### **Certified Action** of the City of Raleigh Planning Commission

Case File / Name:	SP-7-13 / The Pointe at Creedmoor		
General Location:	The southeastern quadrant of Millbrook Road and Creedmoor Road.		
Owner: Designer:	York Development Group Kimley-Horn and Associates, Inc.		
CAC:	Northwest		
Nature of Case:	e: The recombination of two parcels totaling 7.06 acres to construct a 3 building Shopping Center totaling 59,999 square feet. The property is zoned Shoppin Center CUD.		
	Building A – 6,000 square feet Building B – 4,000 square feet Building C – 49,999 square feet		
Key Issues:	As presented, staff finds that this plan conforms to Code standards and adopted land use policies.

#### CA# 1308 Case File: SP-7-13

Site Plan

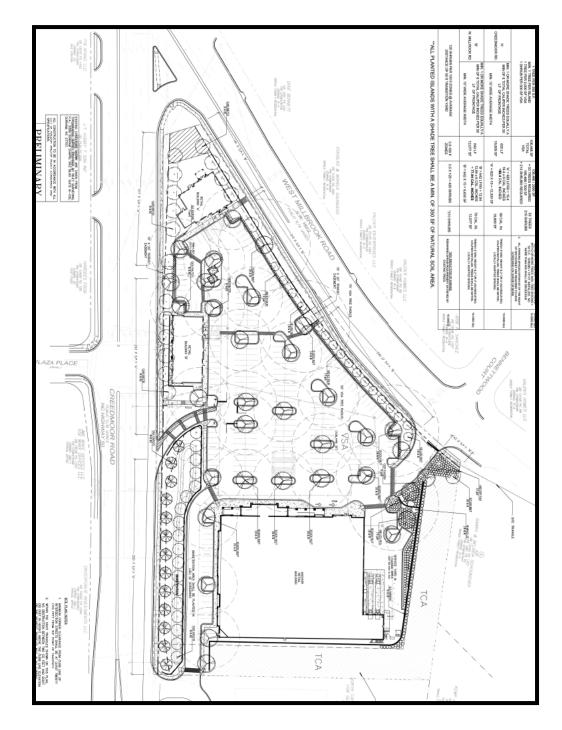
(1) That a minimum of 4 bike racks are provided on the site, as agreed to by the applicant;

- (11) That the plans show the closed wall that screens the dumpster and loading area to be 8' in height consistent with zoning condition(H) and a covenant be recorded with the Wake County Register of Deeds that the dumpsters shall not be emptied before 7:00 am or after 7:00 pm. A copy of the recorded covenant shall be provided to the Planning Department prior to building permit issuance;

- (17) That the site plan be modified to show where the 4 bike racks will be locate;
- (18) That plans are submitted providing the construction of the benches and shelters to be installed within the transit easements consistent with Z-12-12(I);
